MIL-T-60500A(MU)
AMENDMENT 7
20 February 1973
SUPERSEDING
AMENDMENT 6
15 January 1972

MILITARY SPECIFICATION

TRANSCEIVER: 10540501

This amendment forms a part of Military Specification MIL-T-60500A(MU), dated 22 September 1970.

FIGURE 3

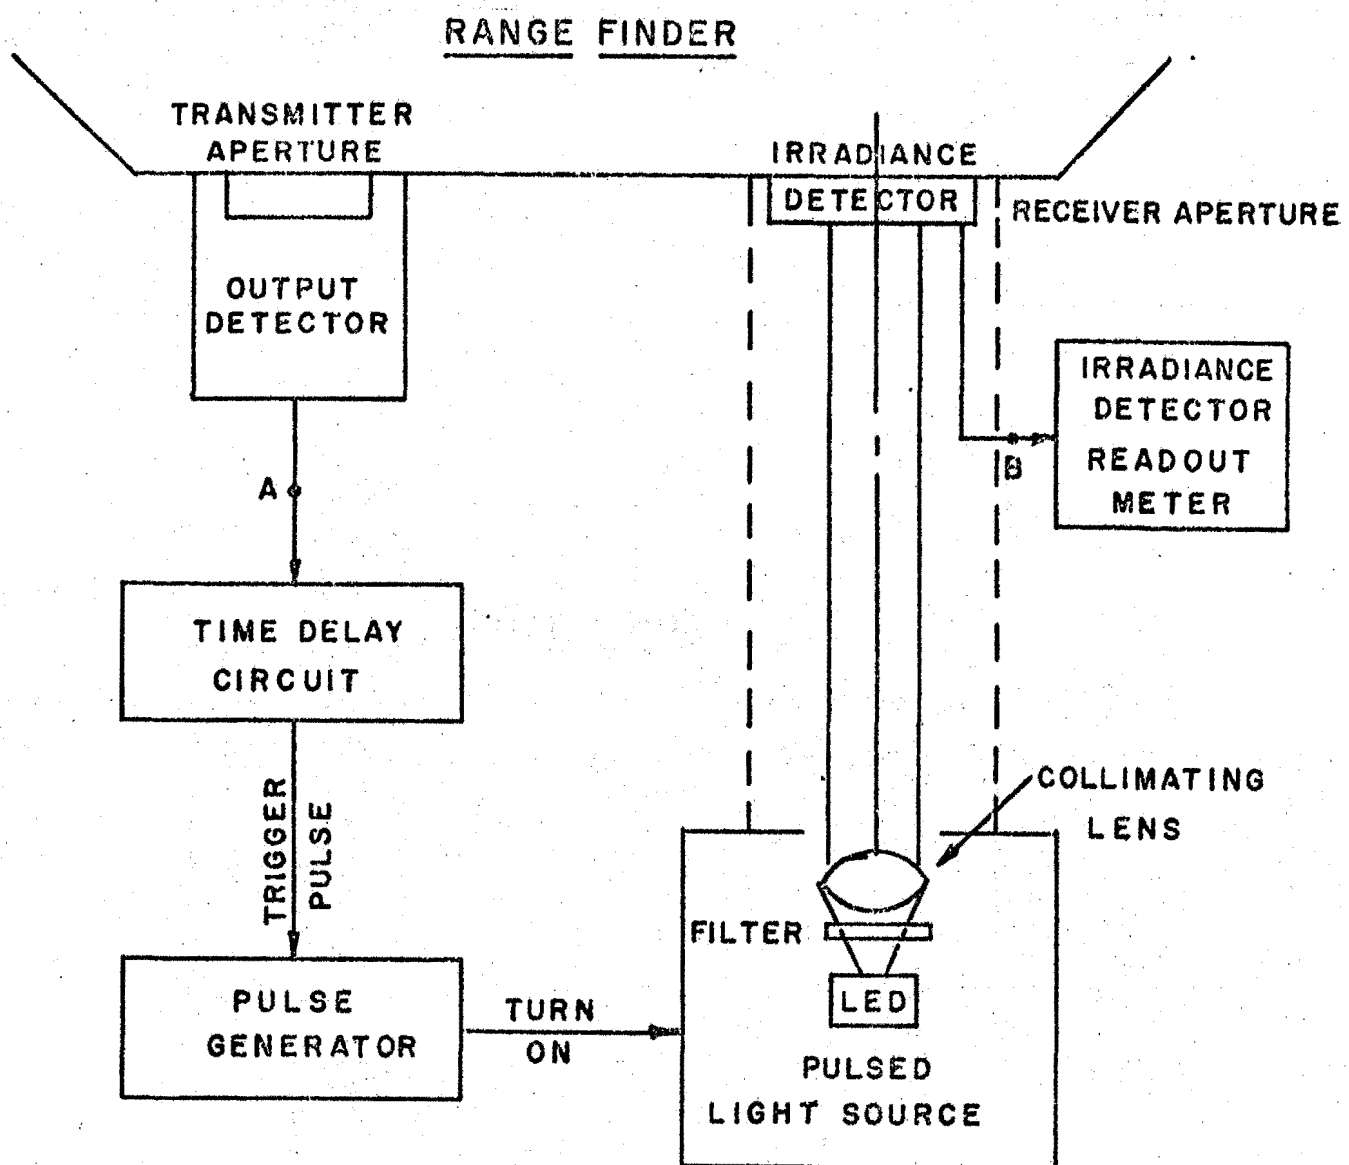
Figure 3: Delete and substitute attached Figure 3.

NOTE: 1. MEASURE TIME DELAY FROM POINT "A" FROM OUTPUT DETECTOR TO POINT "B" FROM IRRADIANCE DETECTOR.

2. ISOLATE THE RECEIVER APERTURE TO PREVENT ERRONEOUS READINGS FROM REFLECTIONS FROM OUTPUT PULSE.
